# **SERVICE INFORMATION NO. SI36-041**

BRP Rotax 912 Series Engines - Fuel Pump

# **EASA EMERGENCY AIRWORTHINESS DIRECTIVE** AD No: 2007-0060R1 - E Date: 20 April 2007 No person may operate an aircraft to which an Airworthiness Directive applies, except in accordance with the requirements of that Airworthiness Directive unless otherwise agreed with the Authority of the State of Registry. Type Approval Holder's Name: Type/Model designation(s): BRP-Rotax GmbH & Co. KG Rotax 912 A series Rotax 912 F series Rotax 912 S series TCDS Number: EASA.E.121 Foreign AD: N/A Supersedure: N/A **ATA 73** Engine Fuel and Control - Fuel Pump - Replacement BRP-Rotax GmbH & Co. KG; Bombardier-Rotax GmbH & Co. KG; Manufacturer(s): Bombardier-Rotax GmbH; All versions of the engine type Rotax 912 A, 912 F and 912 S all serial numbers if Fuel pump part no. 892230, 892232, 892540 (standard version) or part no. 892235, 892236, 892545 (version including flexible fuel line), are installed. These engines are known to be installed on, but not limited to, the following aircraft types: Applicability: Skyfox CA-25, CA-25N; Diamond (formerly HOAC) HK-36R Super Dimona, DV 20 Katana; Aeromot AMT-200 Super Ximango;

(see Fig.1)

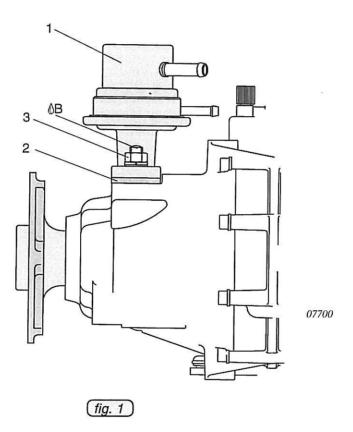
- 1. Remove fuel pump (1).
- 2. Gasket (2) replaced by new part.
- CAUTION: Install new gasket supplied with new fuel pump. Do not reuse old gasket.
- ♦ NOTE: On the sealing surfaces of the gearbox housing and the fuel pump no sealing compound has to be used.
- 3. Install fuel pump.
- 4. Tighten uniformly hex. nuts (3) with LOCTITE 243. Tightening torque 15 Nm (133 in.lb).
- ♦ NOTE: The additional use of LOCTITE 243 should be applied at each removal/replacement of the fuel pump and/or gasket. A rework of already installed fuel pumps part no. 892542 and 892546 is not necessary.
- 5. Install fuel line.
